Yorkshire Green Energy Enablement (GREEN) Project

**Document 8.37 Applicant's Response to the ExA's 8th September
2023 Rule 17 Request for Further Information**

Planning Inspectorate Reference: EN020024

NATIONAL GRID (YORKSHIRE GREEN ENERGY ENABLEMENT PROJECT)
ILLUSTRATIVE PLAN: A659 ACCESS - TADCASTER
REGULATION 5(2)(o)
SHEET 1 OF 2

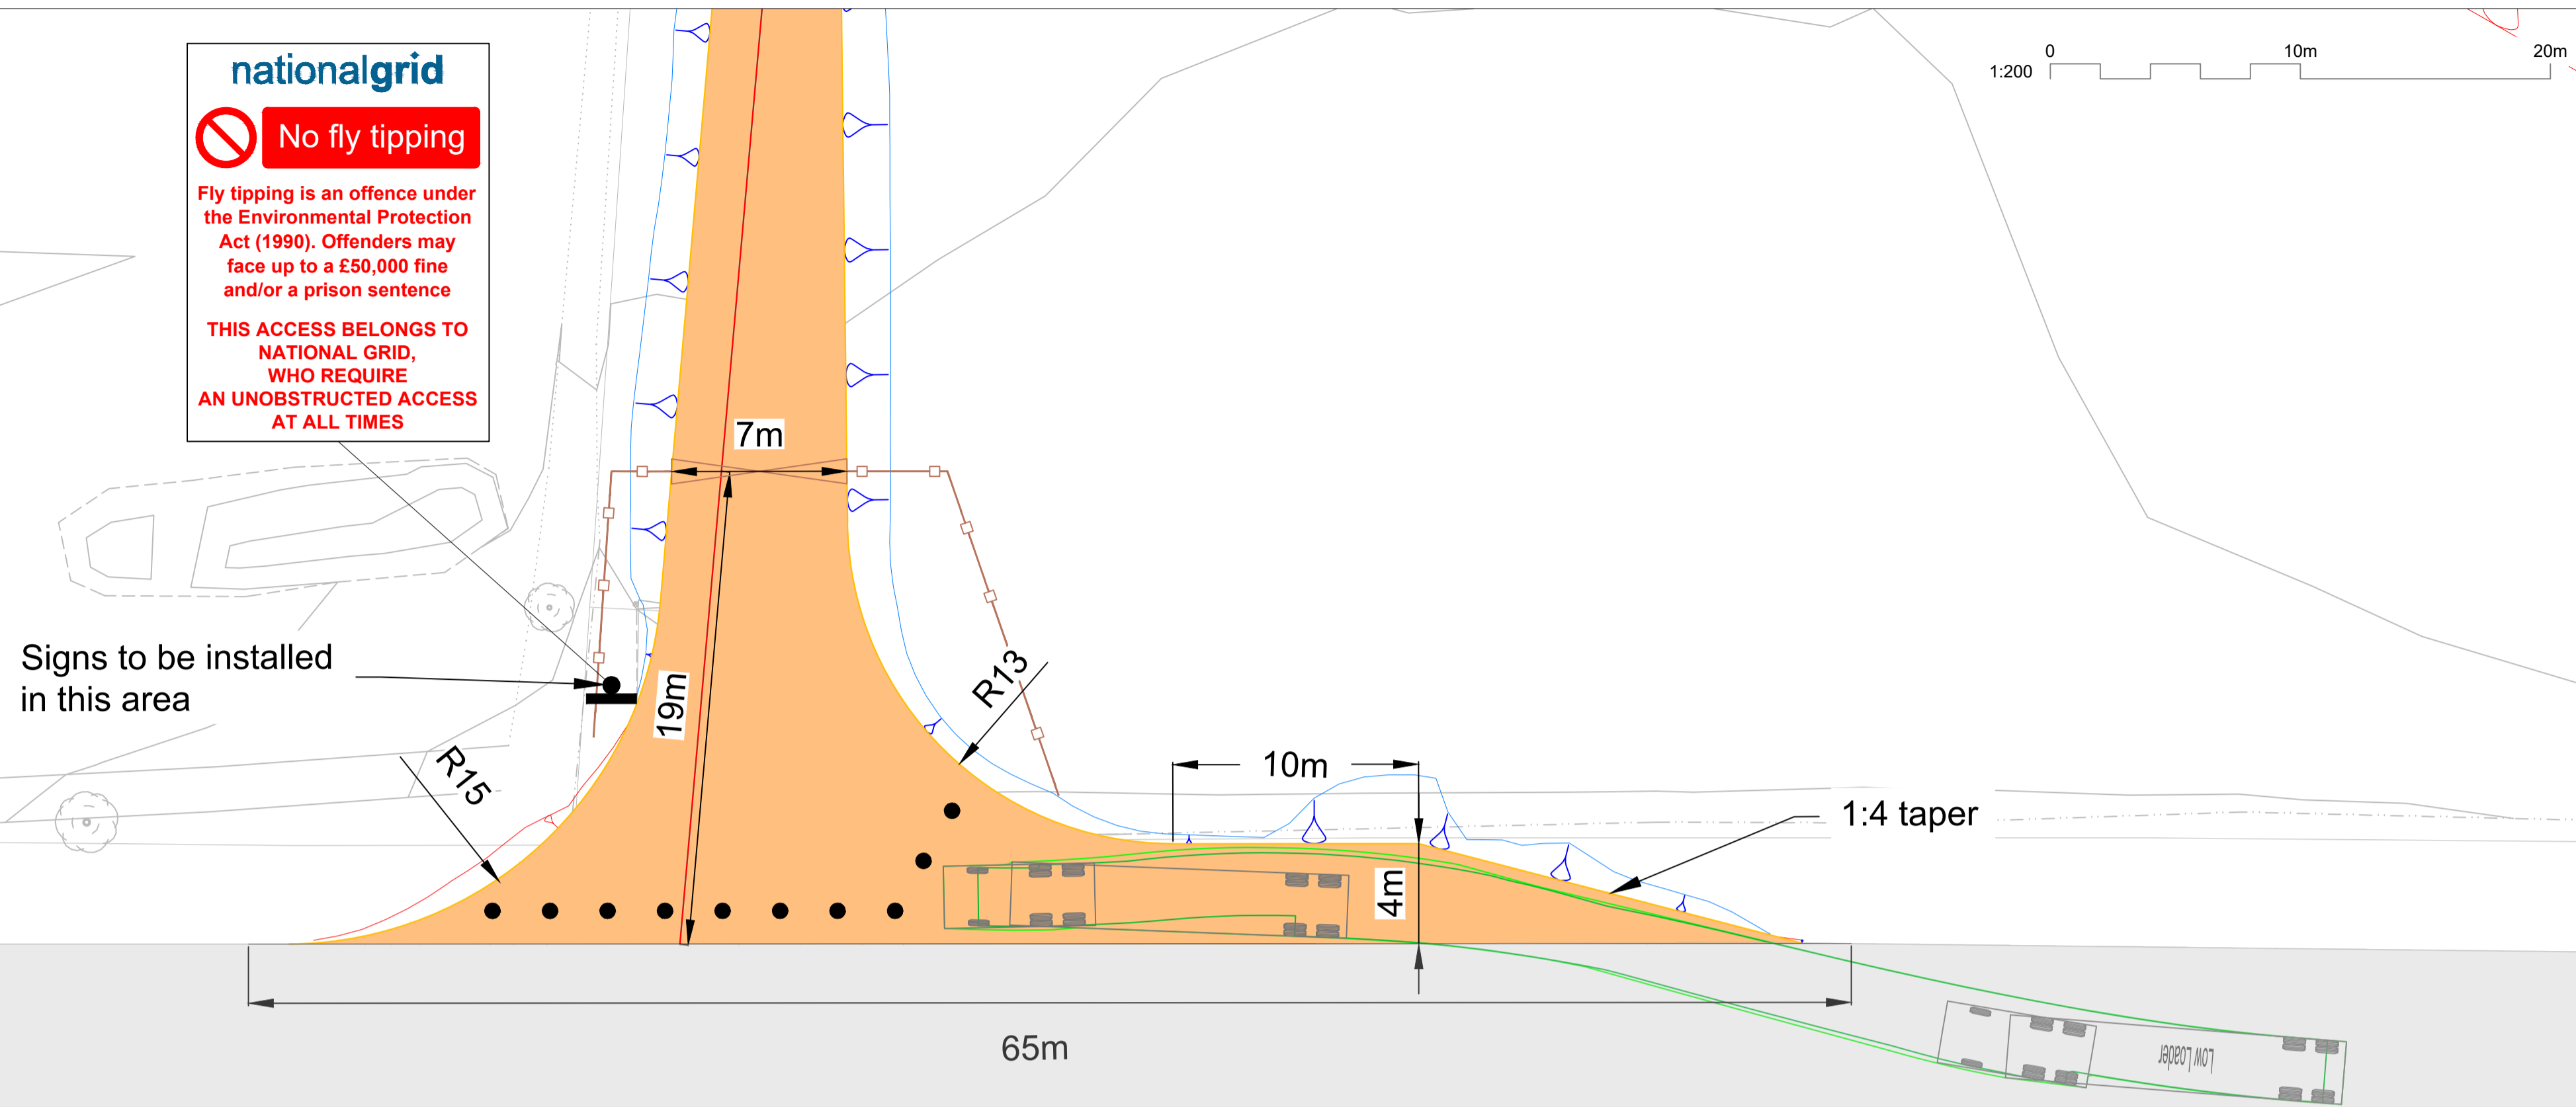
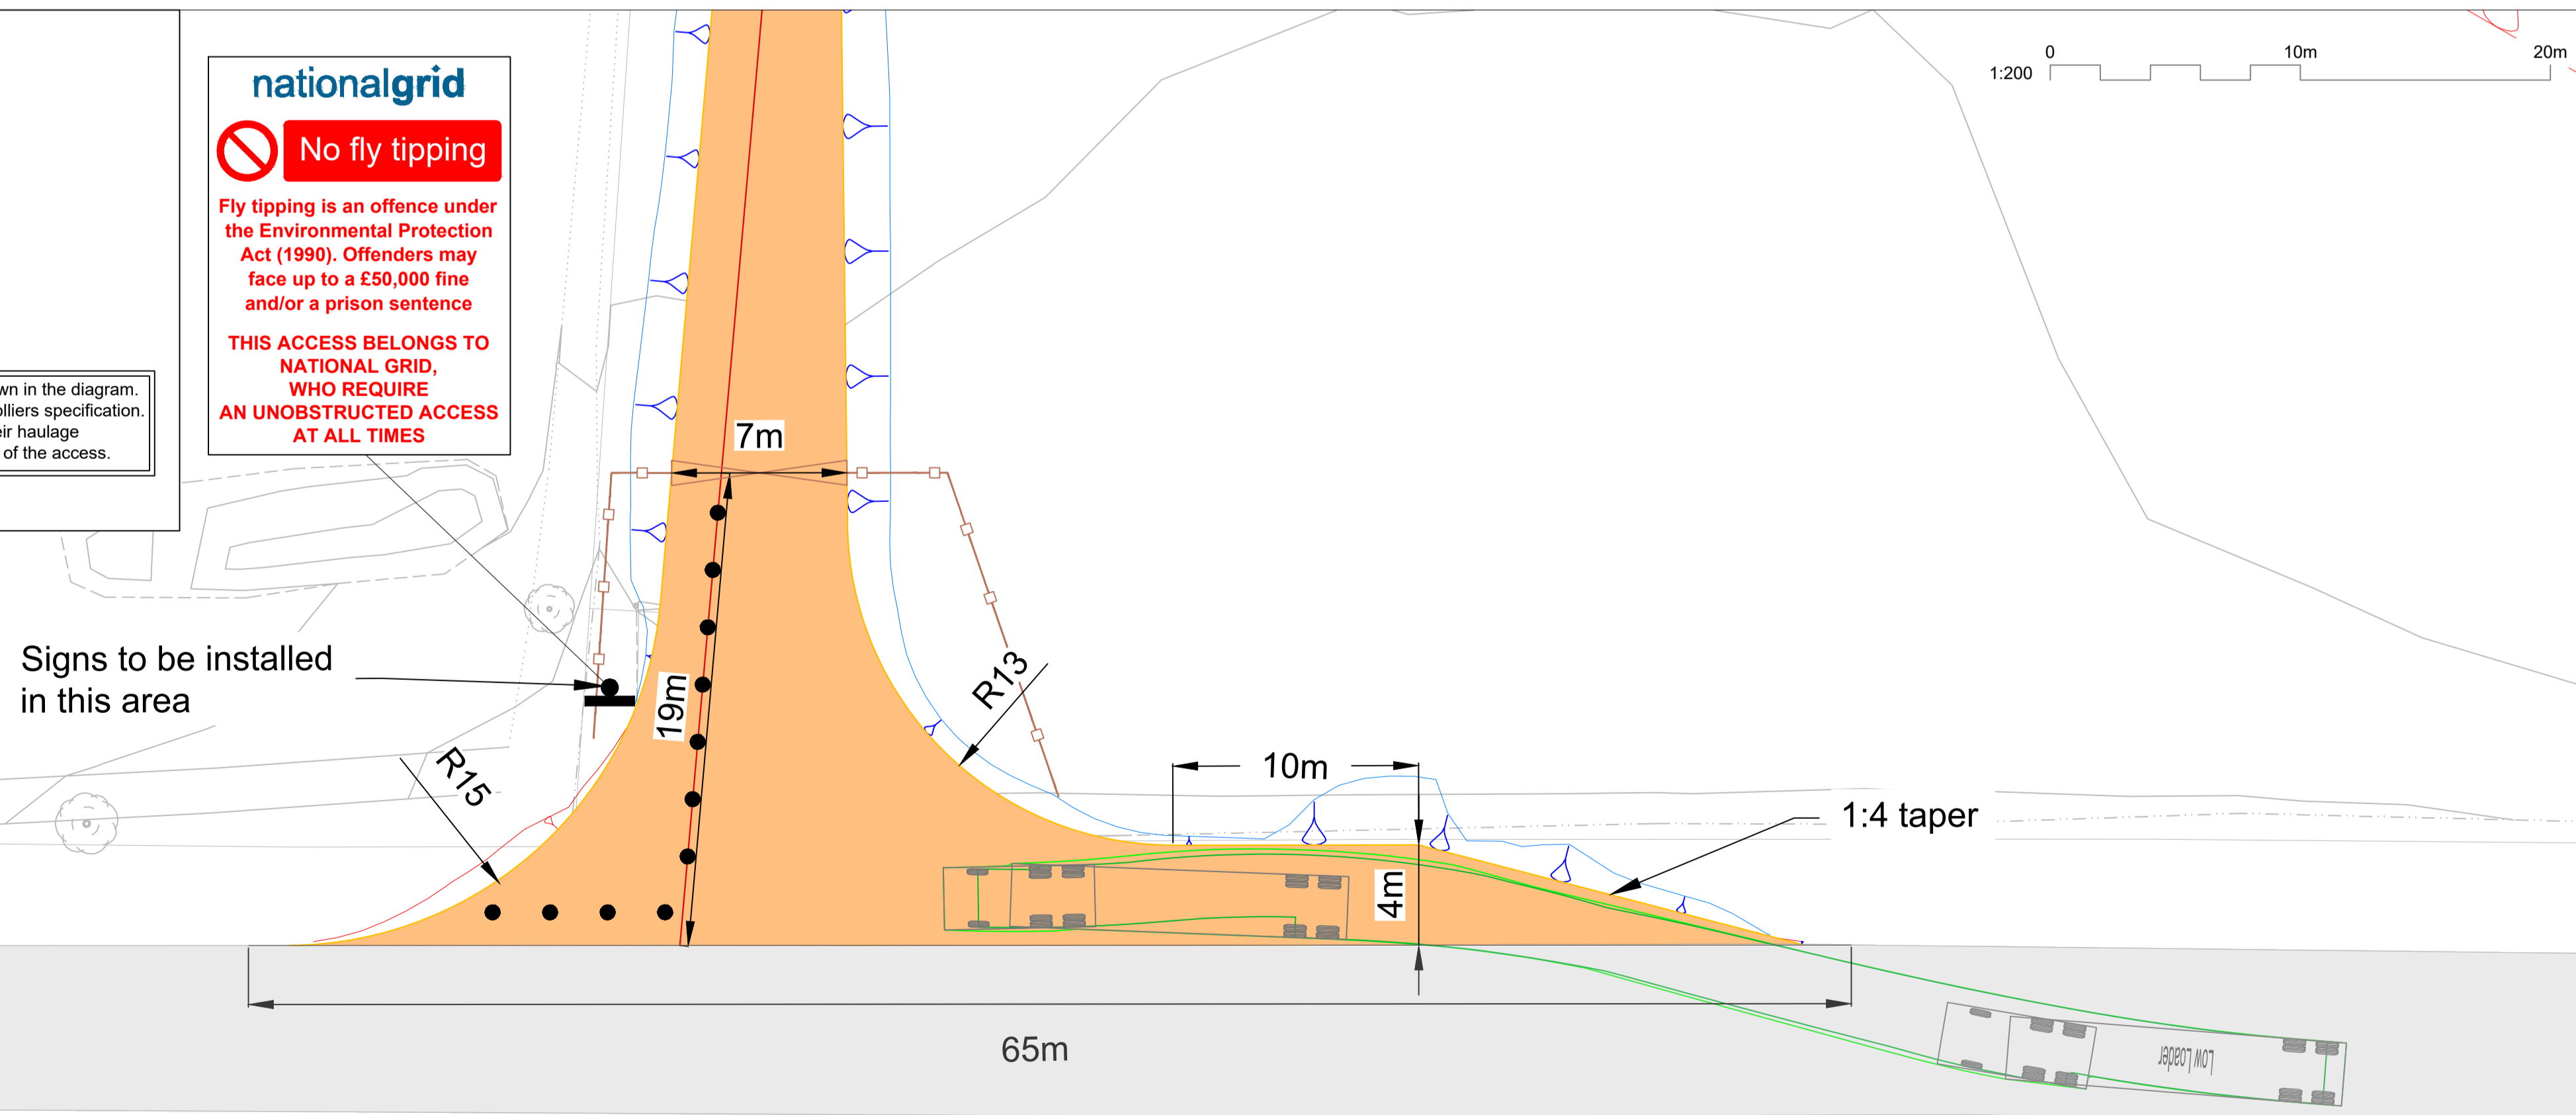
<ul style="list-style-type: none"> • Explain why a track of 7 metres width is shown on the illustrative plan; • If it remains the Applicant’s position that a track with a width of 4 metres could be accommodated, submit a version of the illustrative plan that shows this; and • For the avoidance of doubt, confirm whether the reference to the A361 in the title of Appendix A should instead be to the A659. 	<p>landowner to the Examination, this illustrative plan was also submitted to the Examination in the document referenced above.</p> <p>An access track 7m wide was shown on the illustrative plan as this is the width of the access track included in the application. However as noted above, National Grid considers that a 4m access track could be accommodated but National Grid would require flexibility within the 7m corridor for detailed design of siting and space for drainage of the permanent access. Therefore, National Grid considered it suitable for the illustrative plan to be provided based on the worst case scenario.</p> <ul style="list-style-type: none"> • <u>If it remains the Applicant’s position that a track with a width of 4 metres could be accommodated, submit a version of the illustrative plan that shows this.</u> <p>National Grid has prepared a further Illustrative Plan provided in Appendix B to this document, to provide a representation of what the options may look like based on a 4m wide access. However, this is based on the same dimensions of the bellmouth as shown on the 7m wide access arrangement with the permanent access tapering off to 4m beyond the gate as these remain illustrations prior to detailed design.</p> <p>As detailed above because flexibility is required for siting and space for drainage, this plan is only an illustration and does not represent the exact location of where the access would be located within the Order limits. National Grid has not been able to engage with the landowner on this matter as they have been unavailable for a meeting and no reply was received to National Grid’s emails of 16 August and 5 September 2023 providing the illustrative plan. Therefore National Grid has not been able to progress the development of a potential solution further with the landowner. National Grid will continue to seek to engage Mr Watson and his agent further on the details of the detailed design of the permanent bellmouth and permanent access arrangement should</p>

<p>consent be obtained as it is in National Grid’s interest to reach a solution that works for both parties to secure the access from fly tipping.</p> <ul style="list-style-type: none">• <u>For the avoidance of doubt, confirm whether the reference to the A361 in the title of Appendix A should instead be to the A659.</u> <p>Yes, that is correct the reference in the title should be to the A659 and not the A361. This has been corrected for the 4m access version of the illustrative plan submitted at Appendix B. National Grid has also updated the illustrative plan provided in response to Action 6 at Appendix A of the Applicant’s Deadline 7 Response to CAH2 Hearing Action Points (Document 8.29.5) [REP7-046] submitted at Deadline 7 and this is provided at Appendix C of this document. In doing so National Grid has also corrected a typographical error.</p>
--	--	--
